Planning Commission Meeting Date: March 18, 2010

PLANNING COMMISSION AGENDA ITEM

CITY OF SHORELINE, WASHINGTON

APPLICATION NU	MBER: 201713
AGENDA TITLE:	Continuation of CRISTA Master Development Plan Permit
PRESENTED BY:	Steven Szafran, AICP, Associate Planner
	Steven M. Cohn, Senior Planner

Exhibit 16 – Graphic of Practice Field Study

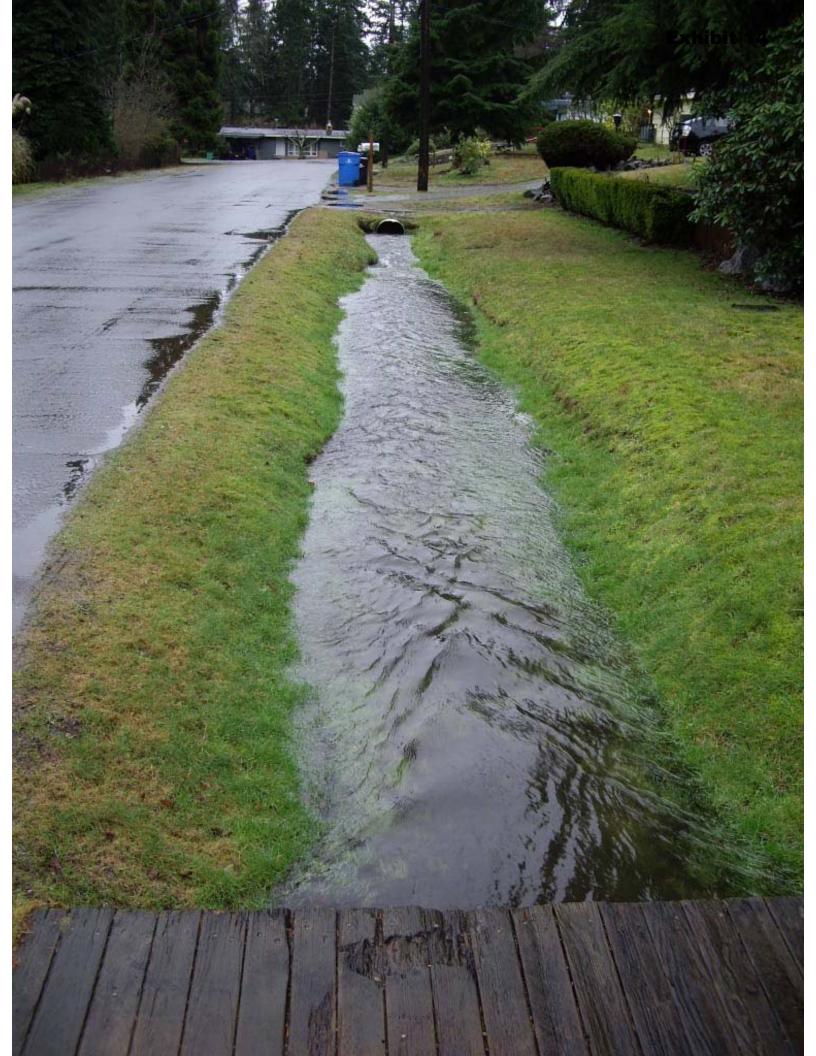
CRISTA has revised the size of the field: the new field will be 190' X 380'. This is 23% smaller than originally proposed.

The total number of trees in the area of the field is 422. The revised field will remove 157 trees. This is 65 fewer trees than originally proposed (see practice field study graphic).

- 3. Athletic Field and Tree Removal
- CRISTA has reduced the size of the athletic field to 190' X 380' which will save an additional 65 trees. This is a 23% reduction from originally proposed.

- The total number of trees in the area of the field is 422. The revised field will remove 157 trees. This is 65 fewer trees than originally proposed (see practice field study graphic).
